Subject: AP1000 COL Responses to Requests for Additional Information (TR #24)

In support of Combined License application pre-application activities, Westinghouse is submitting responses to NRC requests for additional information (RAI) on AP1000 Standard Combined License Technical Report 24, APP-GW-GLR-060, Rev. 0, Reactor Vessel Insulation System – Verification of In-Vessel Retention Design Bases. These RAI responses are submitted as part of the NuStart Bellefonte COL Project (NRC Project Number 740). The information included in the responses is generic and is expected to apply to all COL applications referencing the AP1000 Design Certification.

Responses to Requests for Additional Information on Technical Report No. 24

From Figure 2.4 in ULPU Configuration V Test Report

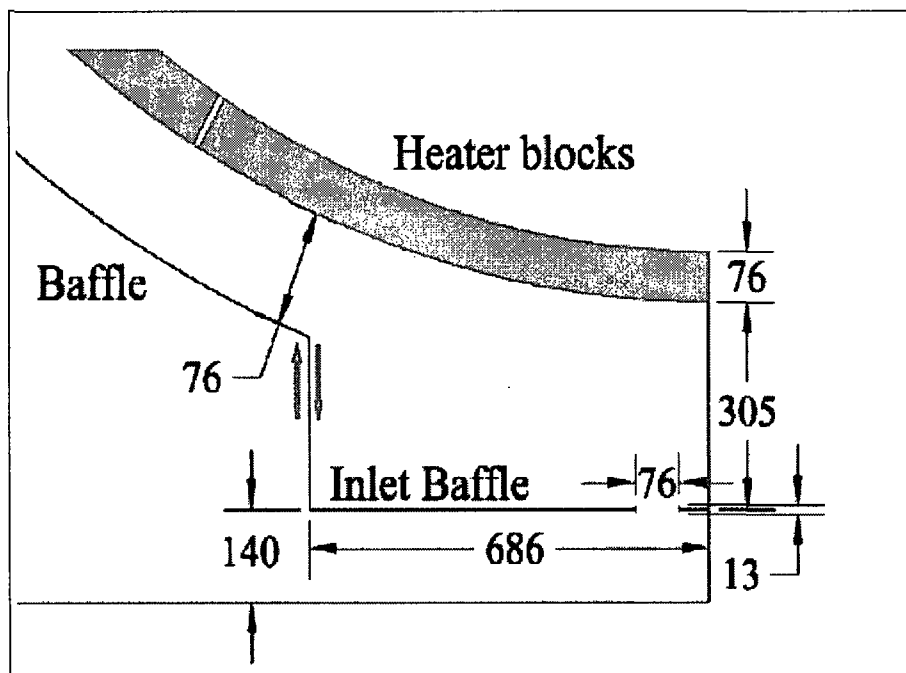
Question: There appear to be some other design modifications between what is described in Westinghouse Technical Report Number 24 (TR #24) and either AP1000 Design Control Document (DCD) Revision 15 or in report CRSS-03/06 “Limits of Coolability in the AP1000-Related ULPU-2400 Configuration V Facility”, dated June 30, 2003.

- a) For example, report CRSS-03/06 “Limits of Coolability in the AP1000-Related ULPU-2400 Configuration V Facility” indicates that the inlet baffle is “plugged” during normal operation using floating balls. (The report does not state whether or not such balls were used during the test to check their ability to open the inlet baffle when needed.) However, the proposed design of the Reactor Vessel Insulation System (RVIS) in TR #24 (with elaboration in report APP-MN20-Z0R-001 R0) has been modified to use inlet assemblies with buoyant doors, instead of floating balls.

Please confirm that the impacts of these design modifications are bounded by the configuration(s) tested in the ULPU-2400 Configuration V Facility, and explain why this is so.

Since simulating the buoyant balls passively floating open was not one of the purposes of the ULPU testing, the balls were not included in the test. Rather the test assumed that the balls would always open and water would freely flow into the AP1000 inlet assembly. The passive actuation feature of buoyancy initiating the IVR flow is retained with the current four door design.

The figure above is from the ULPU Configuration V test report and shows the test configuration that simulates the inlet assembly. In the test, water entered the inlet assembly through a 76 mm hole in the inlet baffle. The hole was sized to provide a flow area that matched the test scale. The test provides representative IVR results for any inlet assembly design that does not impose a greater flow resistance than the test. A lower flow resistance than the test improves mass flow which enhances in-vessel retention (IVR) performance over that predicted by the test.

The AP1000 design provides a flow area through four doors which exceeds the minimum required area by 33-1/3%. In addition the door design provides a lower flow resistance than modeled in the ULPU Configuration V test.

At the top of the inlet assembly, the bottom head insulation has a circular opening to allow water from the inlet assembly to flow into the annulus between the reactor vessel and the RVIS. The radius of the opening in the insulation panels (686 mm shown in the above figure) is the same for the ULPU Configuration V test and for the AP1000 RVIS design.

The lower flow resistance of the AP1000 inlet assembly design enhances the IVR performance observed in the ULPU Configuration V testing.

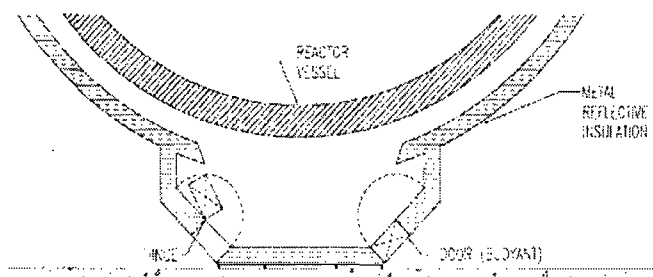
- a) Diagrams in report APP-MN20-Z0R-001 R0 suggest that the inlet assemblies are not at the very bottom of the RVIS structure, but appear to be located some number of degrees of arc away from the very bottom, side-by-side, circumferentially around the structure. The buoyant doors appear to be hinged “on top”, such that the incoming water is expected to force them open in an upward swinging motion.

When the water that enters the annulus makes initial contact with the RPV, it is conceivable that there could be a significant amount of flashing to steam which could locally pressurize this region of the annulus. Because of the way the doors are hinged to “swing upward”, it appears that the local pressurization could be felt “behind the doors”, and possibly impose a closing force on them, which may or may not be greater than the buoyant force trying to open them. The net force calculations in APP-MN20-Z0R-001 R0 did not appear to consider this potential “dynamic backpressure”.

Please provide analytical and/or experimental evidence that the inlet doors, as currently configured will still open sufficiently to provide the required flow area cross-section as specified in APP-GW-GLR-060, given the above potential dynamics.

- a) As shown in Reference 1, the water inlet doors are located on the lower part of four sides of a hopper-shaped inlet assembly. This inlet assembly is located below an opening in the center bottom of the insulation on the bottom head of the reactor vessel. The bottom of each door is inches above the floor of the reactor cavity.

The hopper has flat sloping sides and each side has one door. The doors are spaced so that no door impedes the action of another. The doors are buoyant and therefore float open with water rising in the reactor cavity during an accident. Water pressure or momentum from inward flowing water is not required to open the doors. The following figure from Reference 1 provides a pictorial.

For clarity, this pictorial only shows two of the four doors. For reference purposes, the door on the right is shown closed and the door on the left is shown in its open position due to buoyancy. All doors would normally be in the same degree of openness.

The center of gravity of the open door is at the intersection of the dashed diagonal lines connecting opposite corners of the door. The center of buoyancy of the doors is in the same location as their center of gravity. In the open position due to buoyancy alone, the center of gravity of each door is over its hinge. The door reaches this position well before the water level reaches the reactor vessel bottom head.
